Melrose Promenade – Pike to Pine Neighbors Meeting Notes

Wednesday, February 10, 2021

MELROSE PROMENADE

CHANNELIZATION AND SIGNING

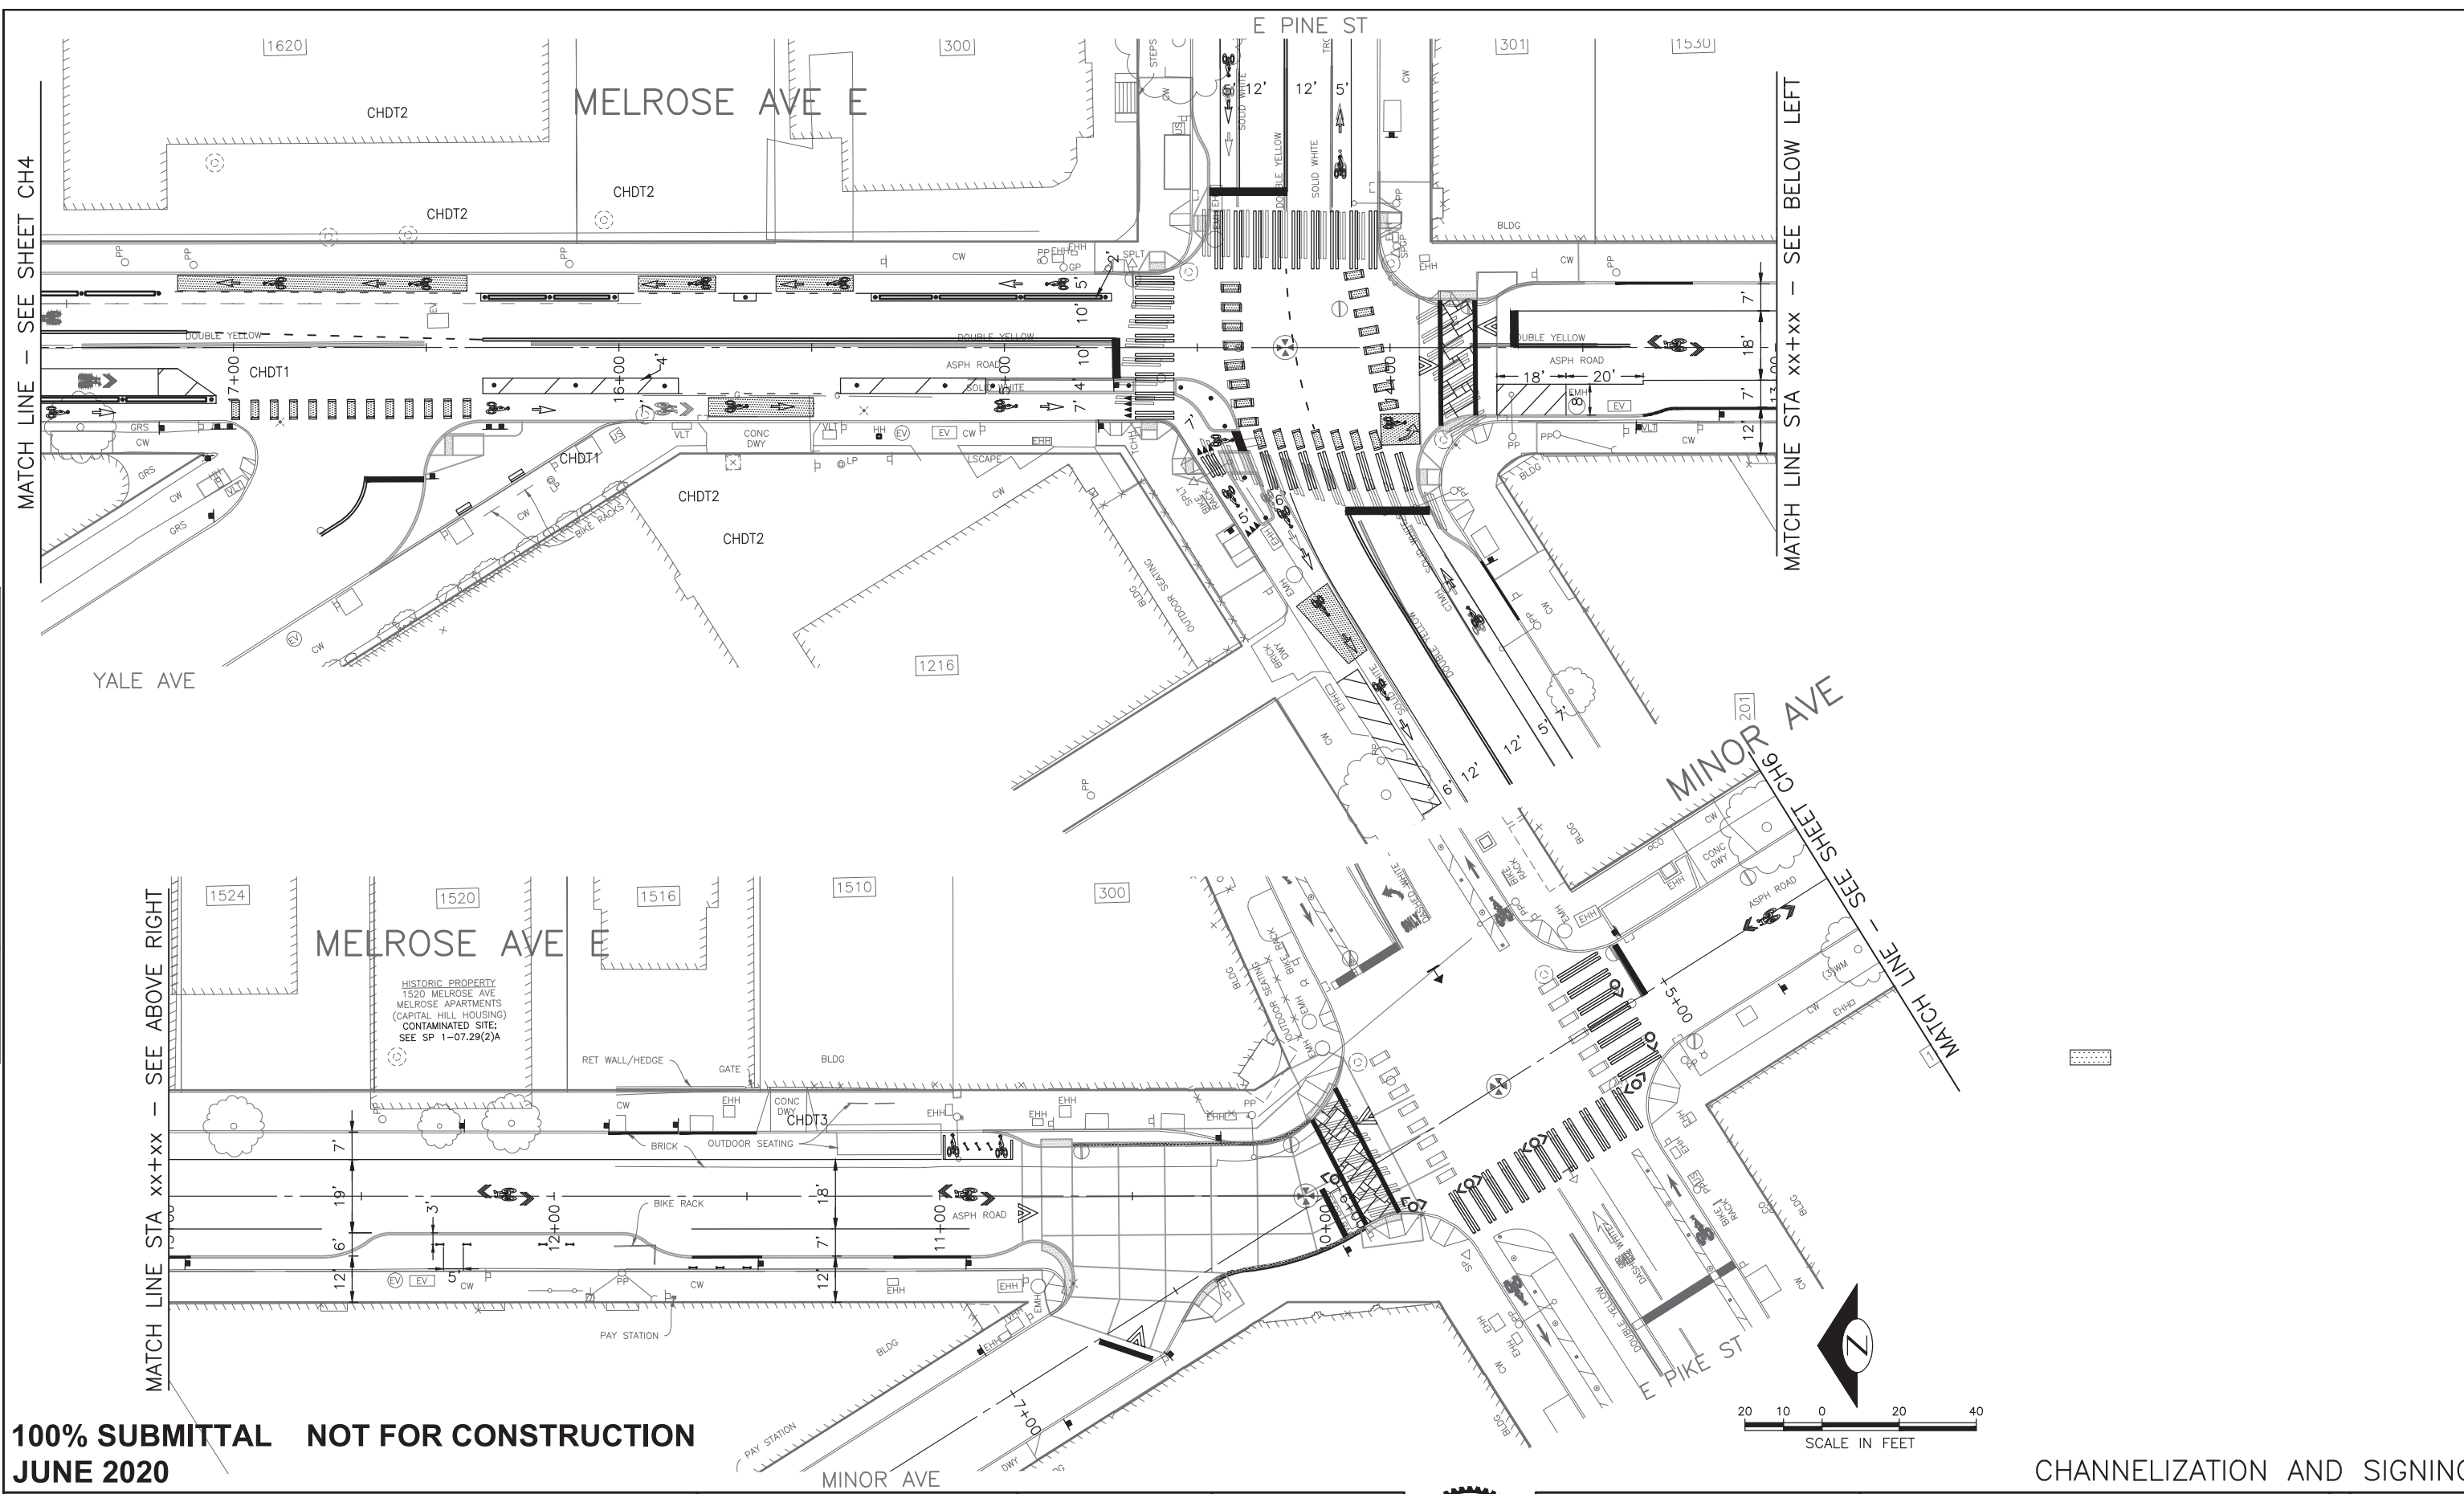
- Are the buildings aligned correctly on the graphics?
 - SDOT to follow-up with plan sheet for Pike to Pine block showing alignment of different project elements compared to the buildings on the street.

- Office of Economic Development can help create signage/advertising for businesses to share information about the project.
- SDOT to send plan set for Pike to Pine block to Pike/Pine stakeholders. [\[See site plan on next page\]](#)
